6C Containment Debris Protection for ECCS Strainers

STD DEP 6C-1 (Figure 6C-1)

STD DEP Vendor

The original DCD text is presented in *italics*, deletions are shown as ~~strikethroughs~~, and new text in underlined regular font.

Figure 6C-1 Cassette Strainer Cutaway

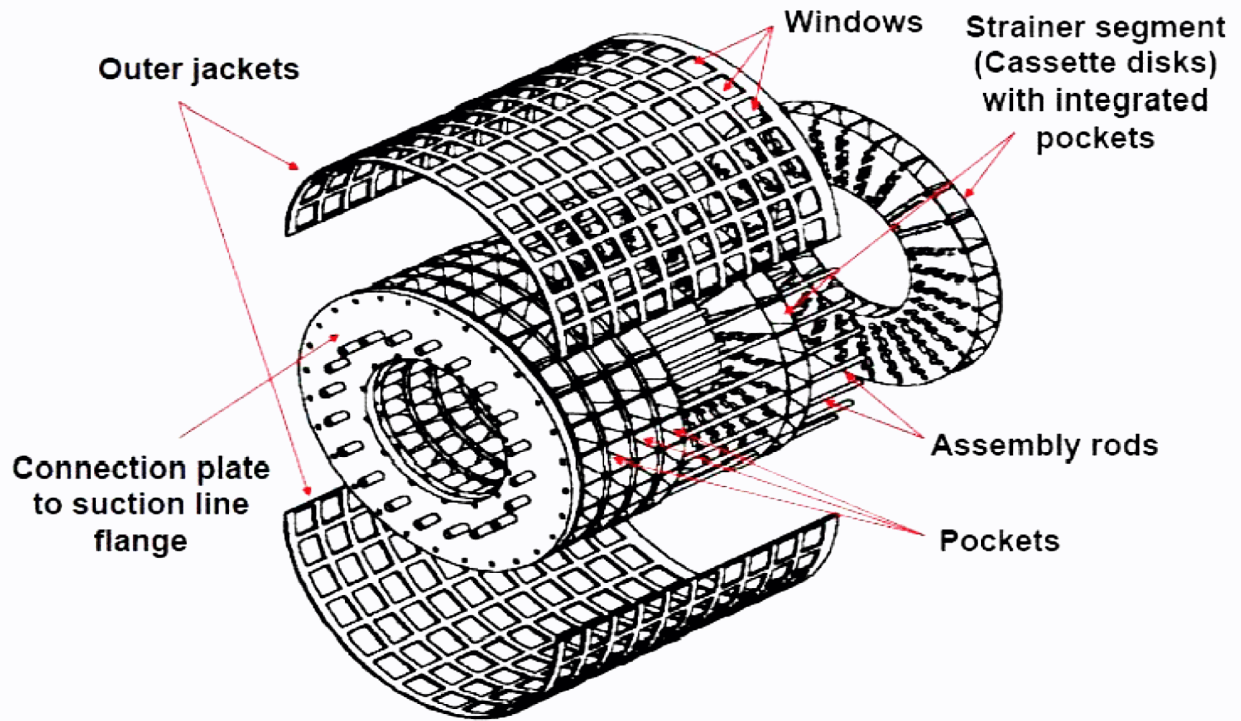
The suction strainers design at Perry preceded and did not meet the current regulatory requirements. The ABWR ECCS suction strainers will utilize a "T" arrangement with conical strainers on the 2 free legs of the "T" a cassette type strainer design. This design separates the strainers so that it minimizes the potential for a contiguous mass to block the flow to an ECCS pump. The design of the strainers will be based on Regulatory Guide 1.82, NUREG/CR-6224 (Reference 6C-4), NUREG/CR-6808 (Reference 6C-5) and the Utility Resolution Guidance, NEDO-32686-A. The cassette type strainer design is based on a set of cassette modules with U-shaped filter pockets attached to the cylindrical outer jacket. Each strainer consists of filter modules, the outer jacket and flange plates on each end of the cylindrical assembly. The filter module is constructed with cassettes which are arranged axially along the strainer axis. One cassette consists of pocket shaped filters which are arranged radially. A cut-away drawing of the strainer is shown in Figure 6C-1. The material used in the cassette type strainer is stainless steel. The cylindrical strainer assemblies are mounted in pairs on piping tees at each ECCS pump suction line. When the ECCS pump operates, the suction flow in the suppression pool runs into all pockets through the outer jacket windows. Each pocket has five flow paths from the inlet through the five perforated walls to the outlet of the pocket towards the cassette strainer. By using the cassettes with the pocket shaped filters, the strainer has an available filter area which is larger per volume than cylindrical and other shaped strainers. The number of cassettes and pockets is adjusted to produce a specific head loss performance for the strainer. To avoid debris clogging the flow restrictions downstream of the strainers, the size of the holes in the perforated sheets is chosen by considering specific flow paths of ECCS equipment and piping (for example, the containment spray nozzle and the ECCS pump seal cooling flow orifices). The strainers will have holes no larger than 2.1 mm.
